*		TM	IC S	PE	CIF	ICA	TIC	NC			NO. S	-1107			
REV:	•														
COMPILED:			CHEC	KED:				APPD:	M	Harry	SHEET	r 1	OF	13	
TITLE:	GPT-10)K to	GPT-4	OK MOI	OIFI	CATION	KI'	T		70					
	KIT-10)6

Modification Kit to convert existing GPT-10K's to accept a 40 kilowatt (PEP) linear radio frequency amplifier.

Kit 106 covers GPT-10K (AN FRT-39B and later), serial numbers from 197 and up.

Figure 2. GPT-10K Before Modification

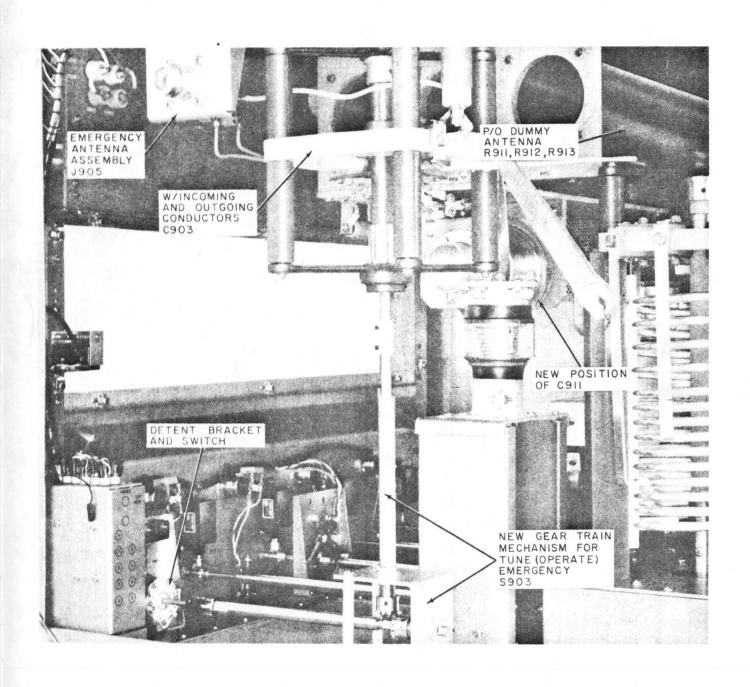
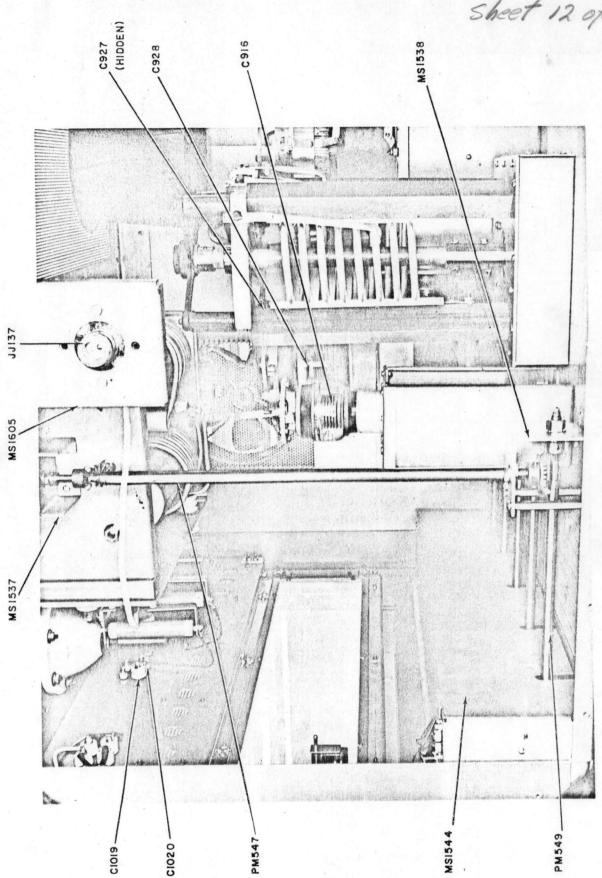
- 1. Referring to figure 2 remove MS 1544, main control panel R.F. shield and place aside for later use.
- 2. Referring to figure 2 remove connections from C927 PA tune capacitor, remove capacitor for later use.

- 3. Referring to figure 2 remove connections from C916, output balance capacitor, remove capacitor for later use.
- 4. Referring to figure 2 remove connections from C928, PA load capacitor, remove capacitor for later use.

- 5. Referring to figure 2 remove connections from C1019 and C1020.
- 6. Referring to figure 2, for dis-assembly of antenna tuner, remove MS 1538 bracket, support, right angle drive and leave in place for later use.

- 7. Referring to figure 2 remove MS 1537, bracket support, right angle drive and discard.
- 8. Referring to figure 2 remove PM 547, vertical drive shaft antenna tuner (discard).

- 9. Remove output load knob on main control panel and save. Now referring to figure 2 remove PM 549 and discard.
- 10. Remove output load counter, discard counter but retain mounting hardware.

Figure 3-1-12. Modified GPT-10K's PA Compartment with Callouts on Changed Components, 45-Degree Angle Side View

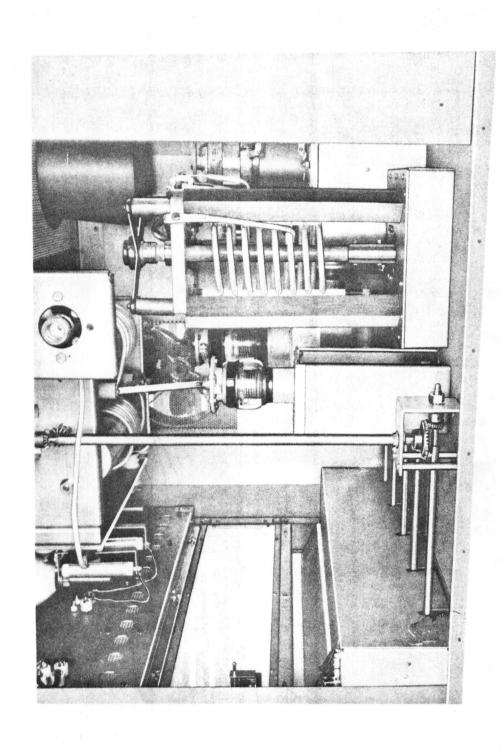
- 14. Replace PA tune, C927 and connect as usual.
 Replace PA load C928, connect as usual, then connect lead from
 C949 to top with lead from band switch. Replace output balance,
 C916 and connect lead from operate position of mode switch to
 the top of C916.

Connect lead from emergency position of mode switch to JJ 177 Emergency output connector.

Connect leads from L916 and L917 to C1019 and C1020 back of meter panel.

- 15. Connect item 9 MS2535 40K RF input strap to the operate position of SW5903.
- 16. Replace inner and outer shield to the 10K (ref. ID 244).
- 17. After all electrical and mechanical items are replaced or installed it would be advisable to check the operation of all control circuits before the completion, that is, mounting of doors, trims and panels.
